**METROPOLITAN COAL PROJECT
RESPONSES TO SUBMISSIONS
PART C**

**METROPOLITAN COAL PROJECT
RESPONSES TO
PLANNING ASSESSMENT COMMISSION QUERIES**

24 February 2009

PLANNING ASSESSMENT COMMISSION
METROPOLITAN COAL PROJECT INFORMATION REQUEST

Figure R-03 Observed Incremental Strain Profiles along Monitoring Line D

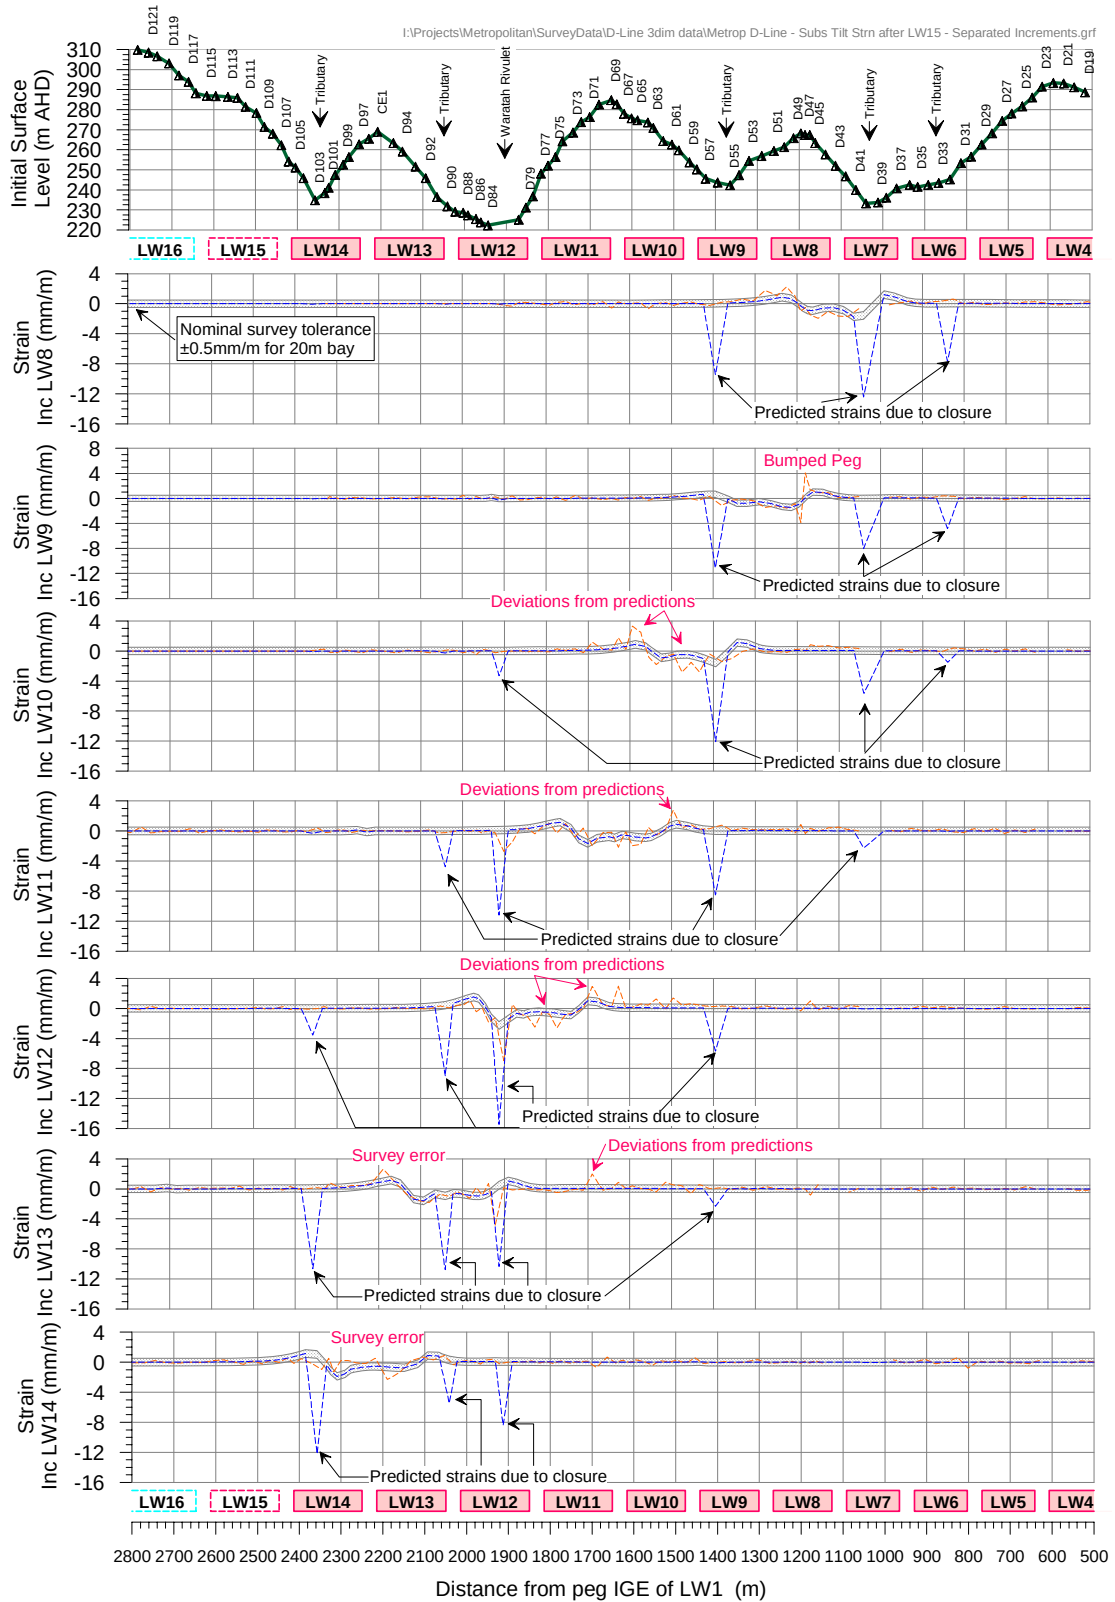
- 18. Figs 3.12 and 3.13 in Appendix A show predicted and observed subsidence and strain profiles along the D survey line, but no data for predicted and observed tilt. Please provide this data. What accuracy is being assigned to predictions of tilt?**

In order to present a clearer comparison of the observed and predicted strains, the plots of observed and predicted incremental strain have been presented as individual plots for each of the longwalls from LW8 to LW14 and are presented in Figure R-03. Annotation has been added to these plots to identify any of the known non-systematic movements. The predicted closure strains at each of the drainage path crossings is plotted along the predicted line. The plots also show the expected range of survey tolerance for strain which is estimated to be ± 0.5 mm/m. The survey tolerance was only applied to the predicted systematic strain plot, not the closure strain spikes.

It can be seen that the general distribution of the observed incremental strains match the predicted strains. The scatter created by survey tolerance can be seen more clearly in the individual plots on Figure R-03. There are several relatively significant spikes in the observed profiles for LW10, 11 and 12, at the hill from approximately Peg D57 to Peg D80. It is known that large horizontal movements occurred over these pegs during the extraction of LW10, 11 and 12 (both along and across the D Line) and that a large tensile crack occurred near the top (and on the western side) of this hill during the extraction of LW10.

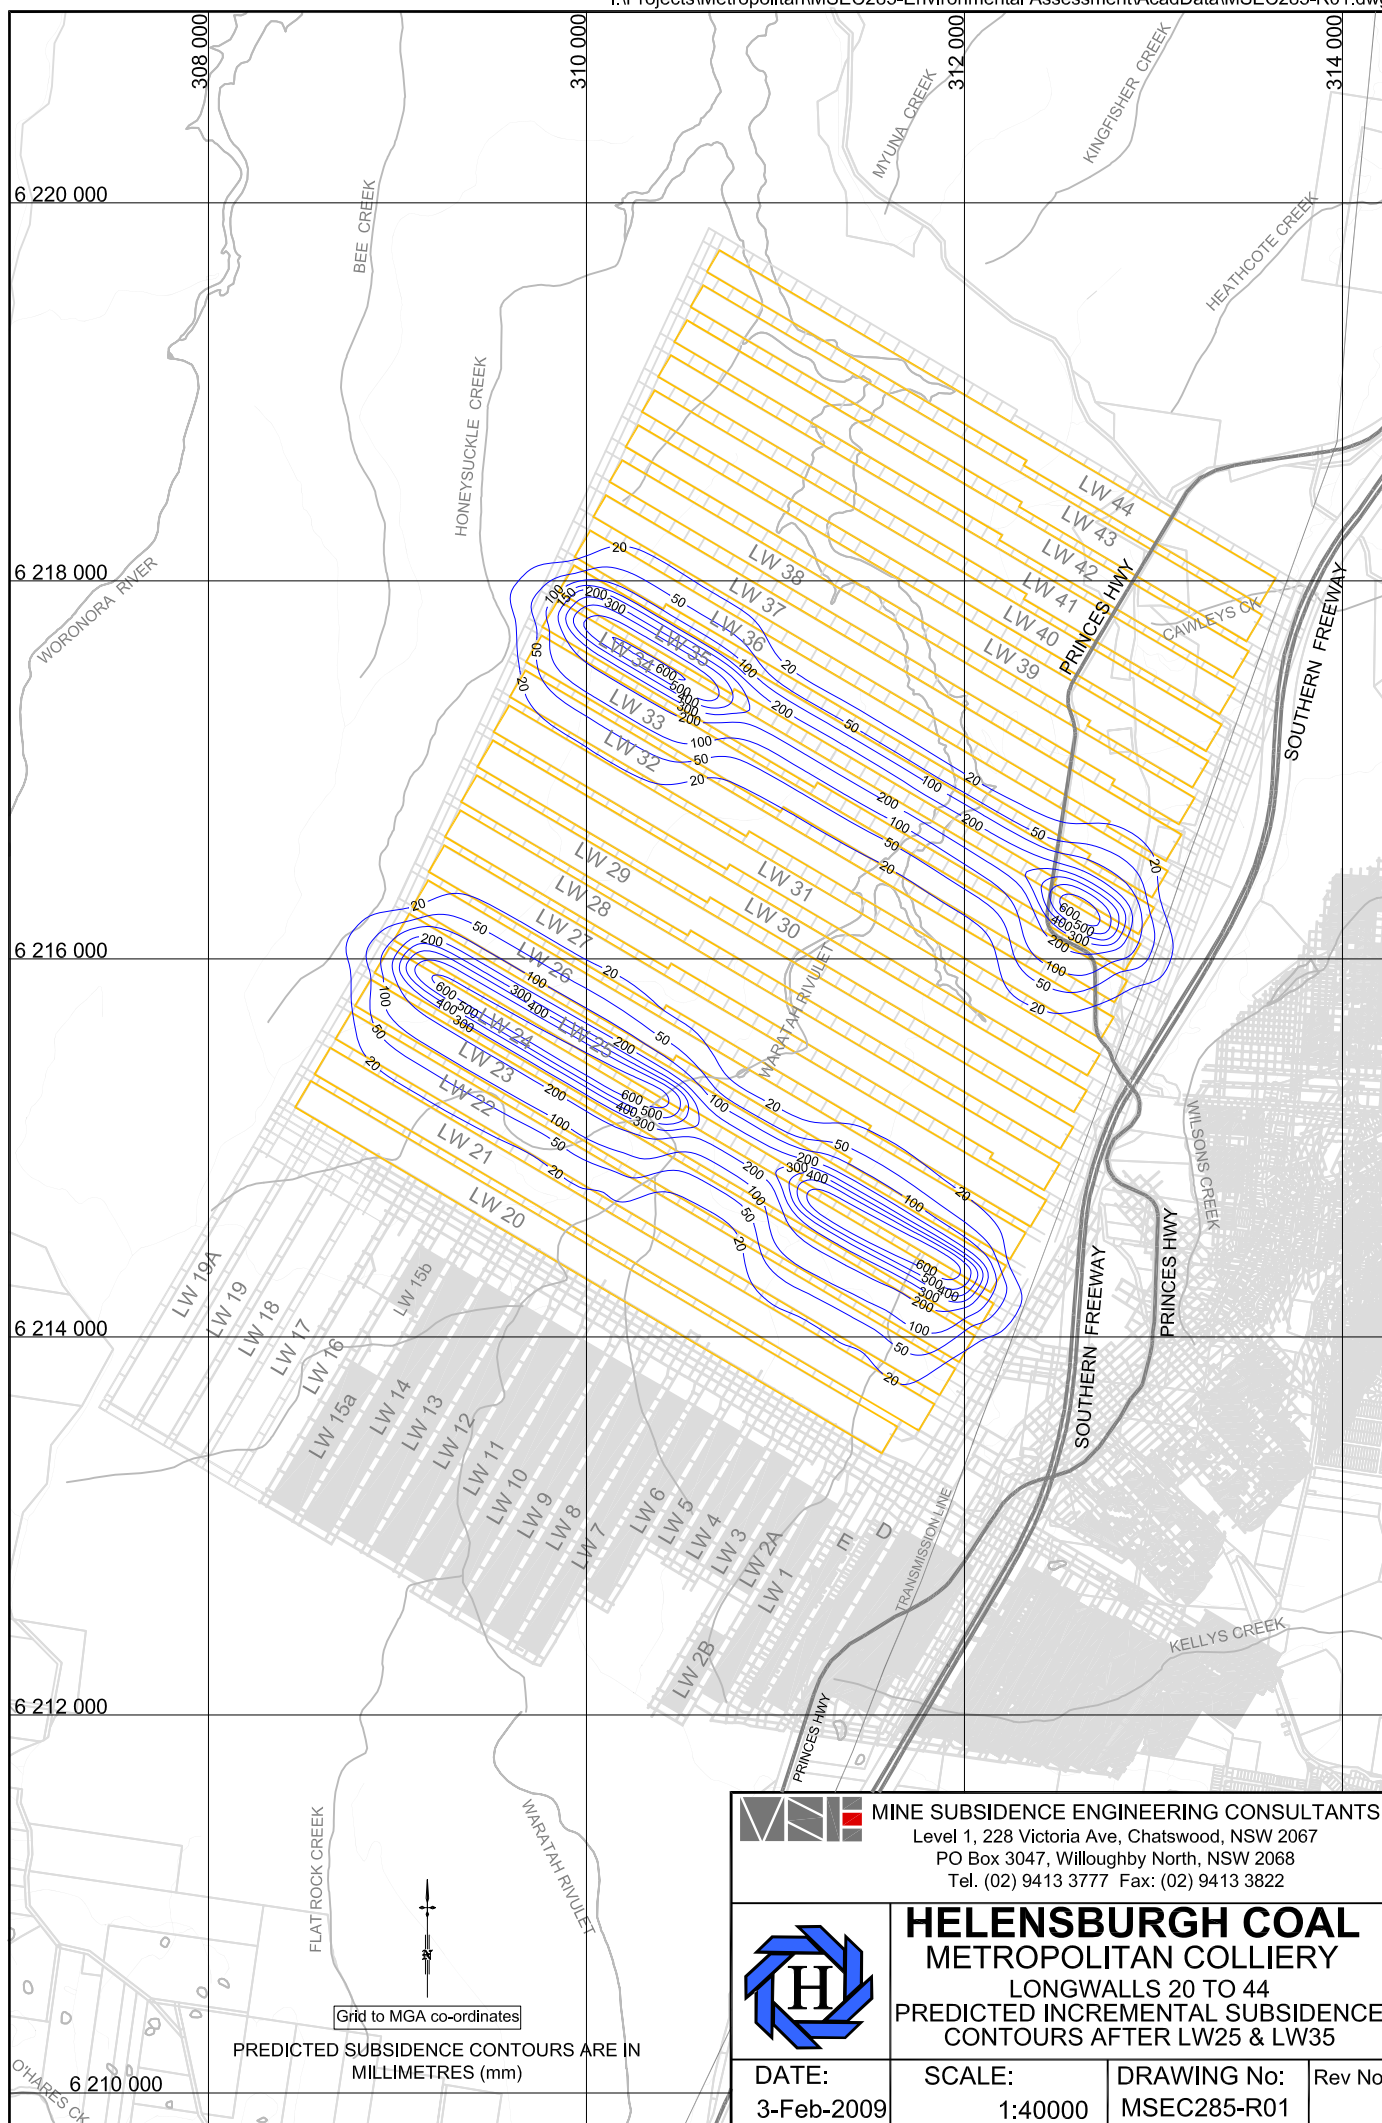
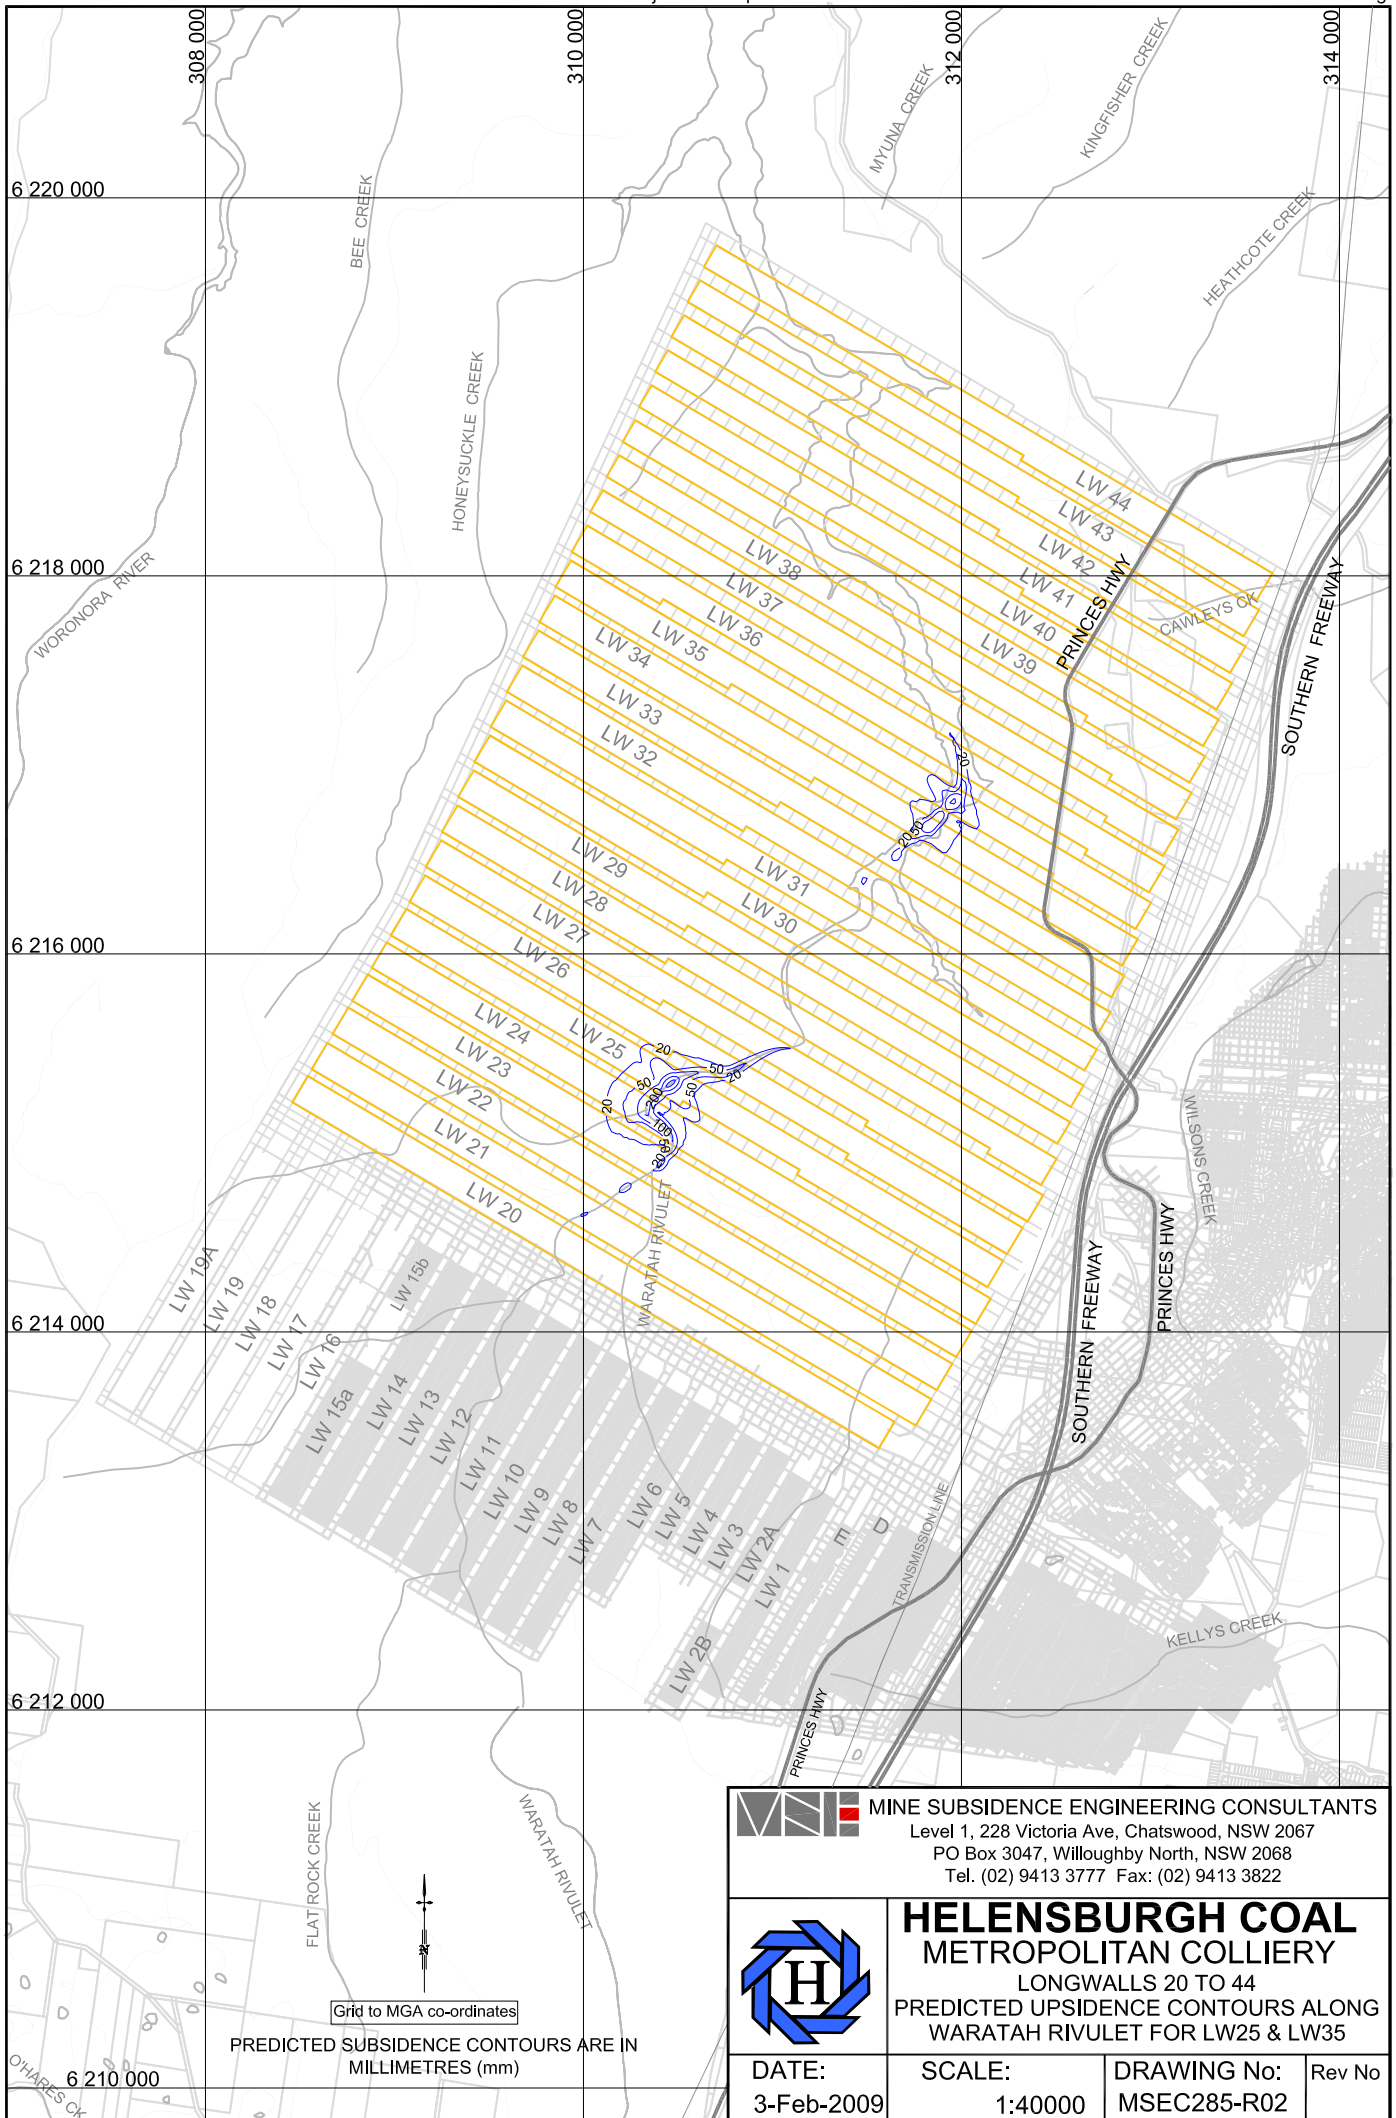
- 20. *Drawing No: MSEC285-20 in App A shows total vertical subsidence in plan view over the whole study area. However, there are no similar plots of total net vertical displacement. Please provide plan view drawings for subsidence effects, including upsidence and closure, that cover the full study area (ref. Table 5.8 in Appendix A).***

It is extremely difficult to prepare a meaningful contour plan of the total net vertical displacement over all of the proposed longwalls. In lieu of this, MSEC has prepared plots to show the effect of the predicted incremental upsidence on the incremental subsidence contours. These were prepared for two longwalls, LW25 and LW35, representing an area with larger values of subsidence and an area with smaller values of subsidence. MSEC has prepared contours showing the predicted incremental subsidence (Figure MSEC285-R01), predicted incremental upsidence (Figure MSEC285-R02), and predicted incremental subsidence plus upsidence or net vertical displacement (Figure MSEC285-R03).

Figure GW-3. Contours of total piezometric head [mAHD] along column 100 for “recent” mining consisting of Longwalls 1-14 (green in Layer 12) and neighbouring mines (yellow in Layer 12): [a] Standard-MODFLOW; [b] MODFLOW-SURFACT

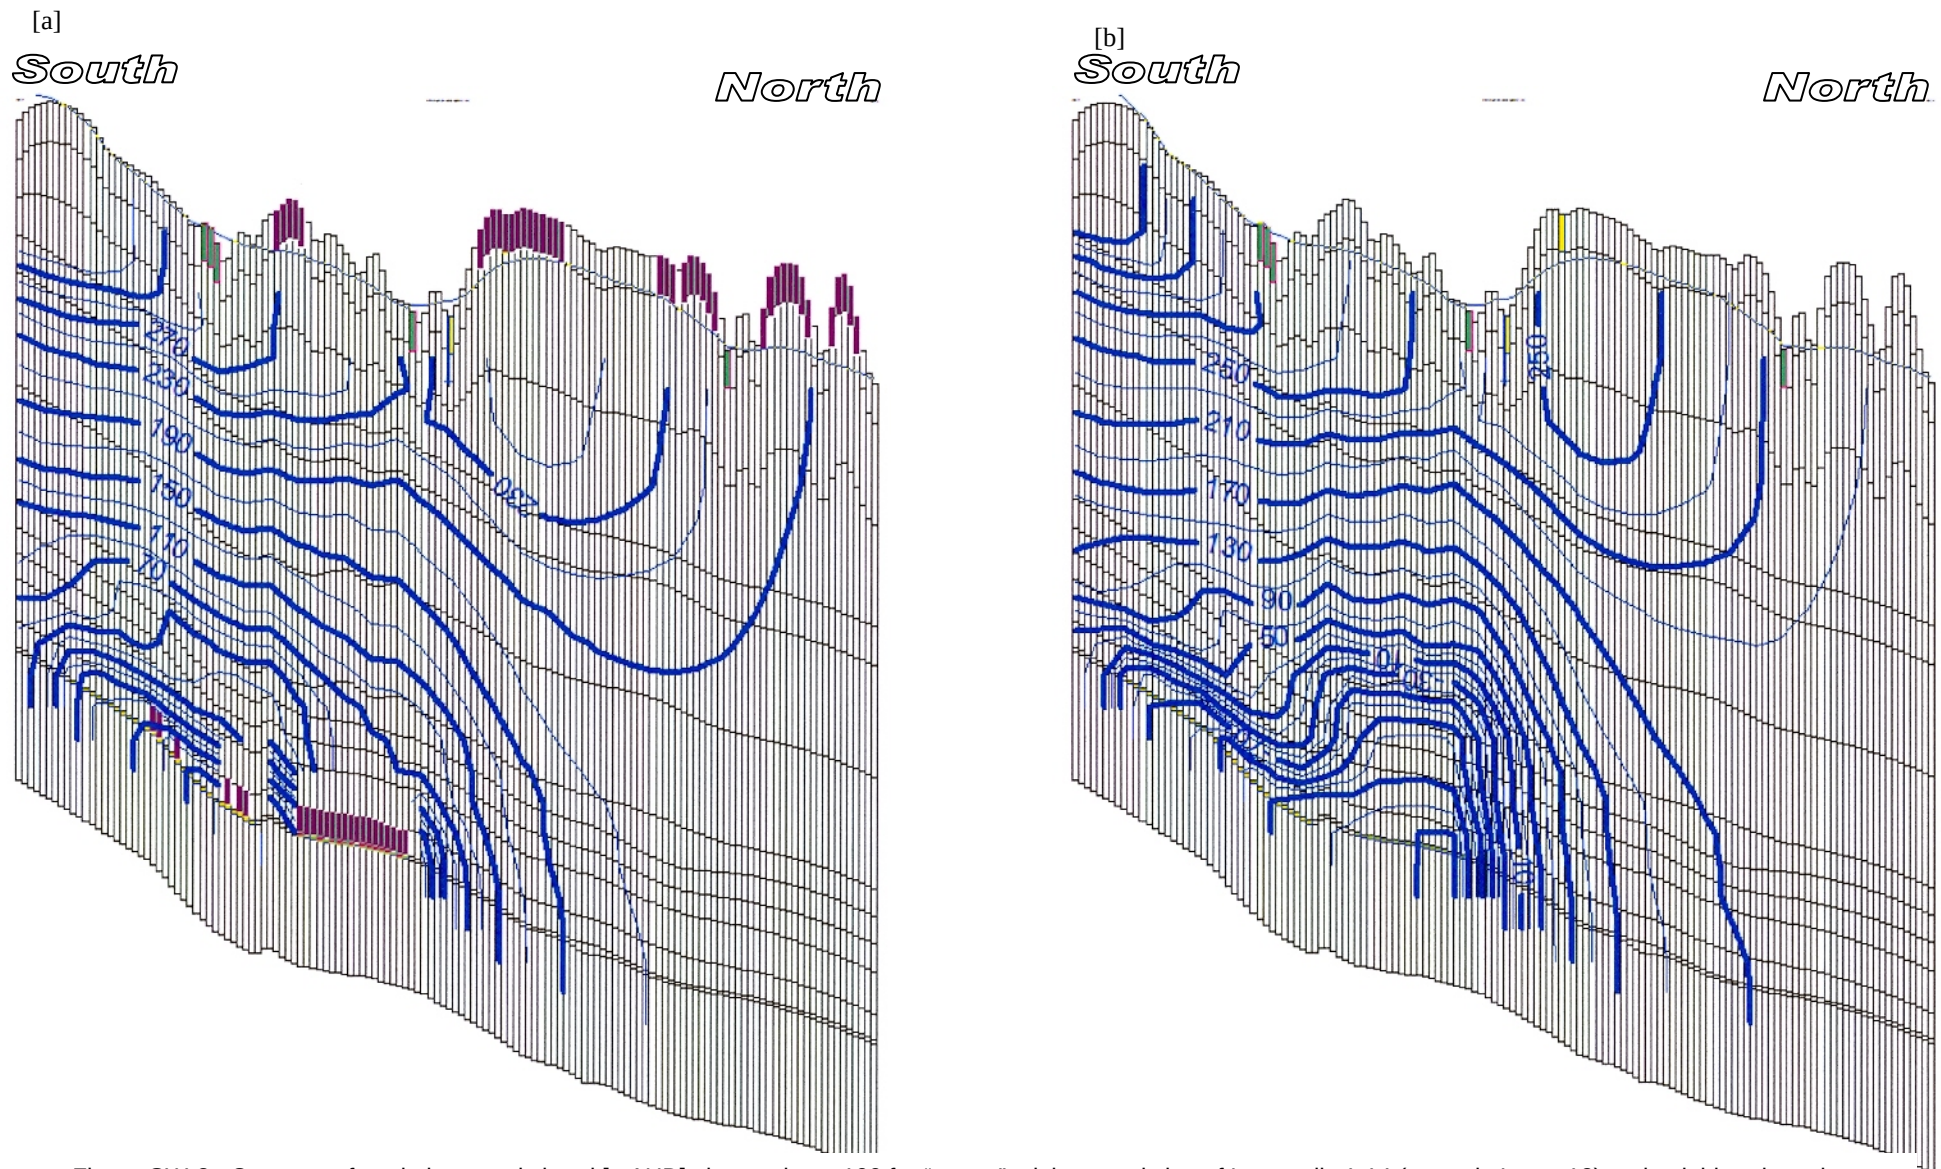
44.	Groundwater modelling in the EA utilised Modflow while modelling in a more recent report utilised the Surfact variant. It would be useful to see and compare a vertical section plot for each model which clearly shows contours of formation pore pressures - say column 100 in the model (steady state). This section needs to be generated in sufficient detail to indicate the freely draining zone above goaves for current and proposed longwalling.	Page 117

For the *recent mining* scenario, the comparison of simulated groundwater level contour maps is presented in Figure GW-3. The relatively thin coal seam (Layer 12) is colour coded where mining is active – yellow for neighbouring mines; and green for Longwalls 1-14 (in accordance with Figure GW-1). Figure GW-3(a) shows “dry” cells (purple) above the coal seam in Layer 11 (Coal Cliff Sandstone) for Standard-MODFLOW. MODFLOW-SURFACT [Figure GW-3(b)] shows continuity of heads across all layers, with significant depressurization over and above the longwalls, and apparent drainage towards the goaf. *[The height of depressurization can be gauged from the thickness of the bottom layer, which is 100 metres thick.]*
